Energy - Docket Optical System

From: Wilkins, Arnold J <arnold@essex.ac.uk>
Sent: Wednesday, February 04, 2015 2:18 AM
To: Energy - Docket Optical System
Cc: Shirakh, Maziar@Energy; Lee, Simon@Energy; Jon McHugh; McGaraghan, Michael (mmcgaraghan@energy-solution.com)
Subject: 14-BSTD-01
Attachments: Screen Shot 2015-02-04 at 09.47.26.png

2016 Building Standards Update

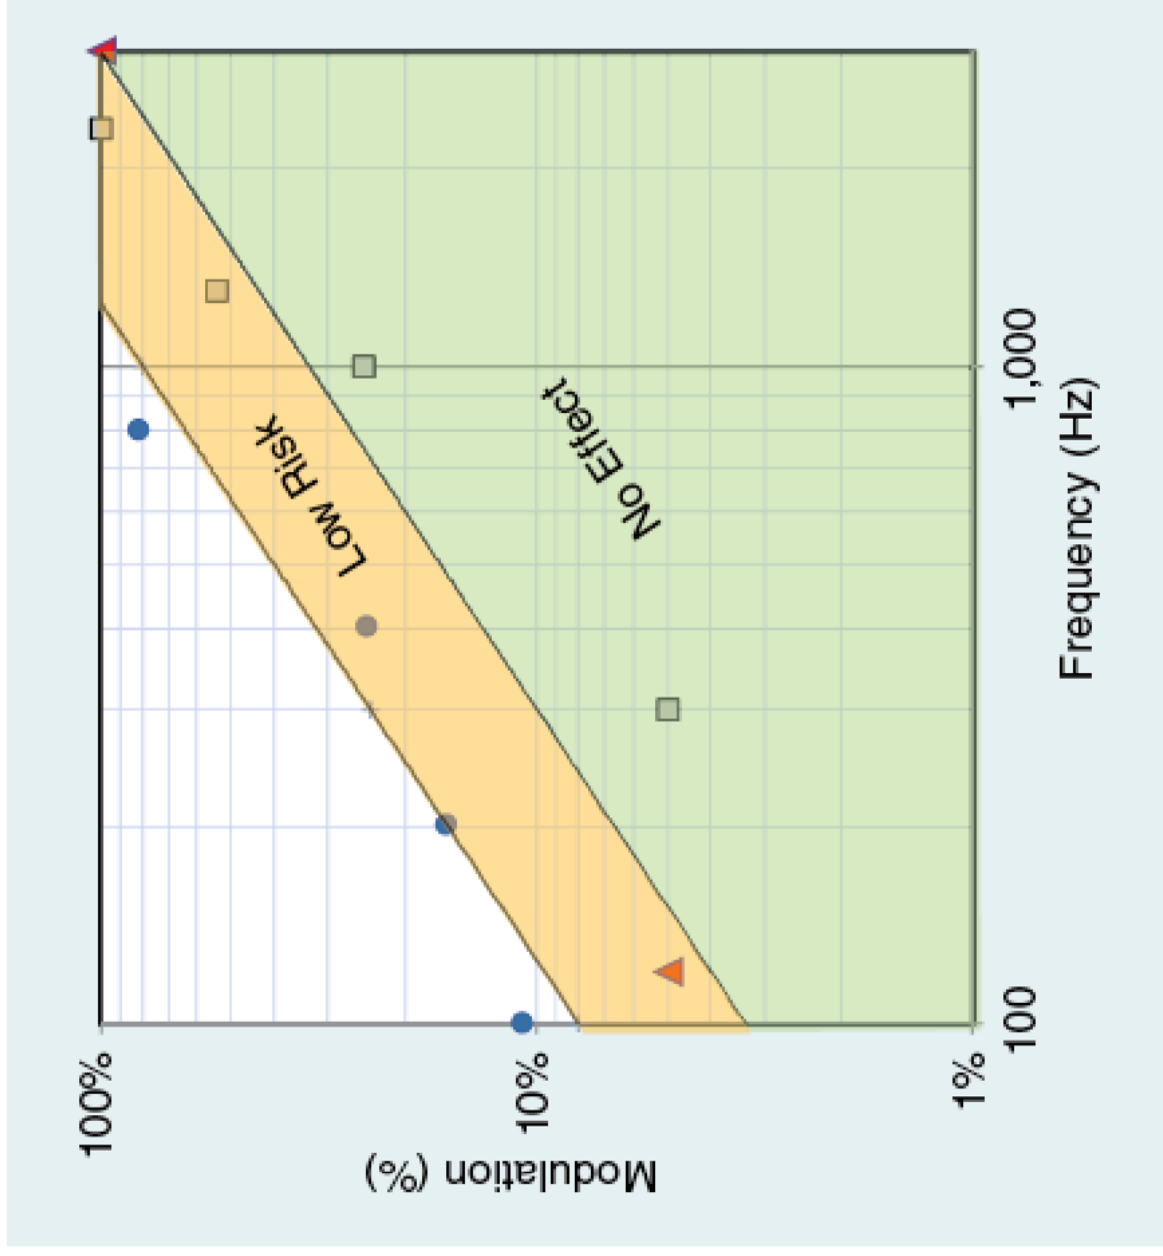
I have researched the effects of lighting flicker on headache and ocular motor control for the last 30 years. The standards that you are proposing are nowhere near stringent enough to reduce the symptoms induced by flicker. It is a major innovation, however, to insist on the measurement of flicker, and it can only be hoped that over time the criteria will become more stringent.

Under worst case conditions, flicker can be seen by most observers at frequencies of about 2kHz. The perception can be made during a saccade, when the eye is moving extremely rapidly, and any intermittent illumination becomes a spatial illumination of the retina during the flight of the eye. It turns out that the conditions under which flicker is visible (as pattern) during a saccade closely resemble those at which symptoms are generally reported. There is evidence that (at least at 100Hz) flicker disturbs the control of eye movements. This may be because it is known to cause phase-locked firing of neurons in brain regions responsible for the timing of eye movement.

The attached graph shows the no-effect region for flicker expressed as a joint function of flicker frequency and modulation depth. The curve does justice to the available evidence from several studies of the stroboscopic effect (the intermittent appearance of a moving object under flickering illumination) and the phantom array (the appearance of pattern during a saccade). These studies used a variety of waveform shapes, and yet the characterisation of flicker in terms of percent modulation provides a reasonable fit. It is acknowledged that this approach takes insufficient account of the effects of waveform shape and it is hoped that in the future it will be possible to use the attached curve together with waveform characterisation in terms of Fourier components. The curve has been published in an article by Prof Brad Lehrman (Northeastern U) and myself in IEEE Power Electronics Vol 1 No 3 Sept 2014, and it forms the basis of the forthcoming IEEE1789 standard.
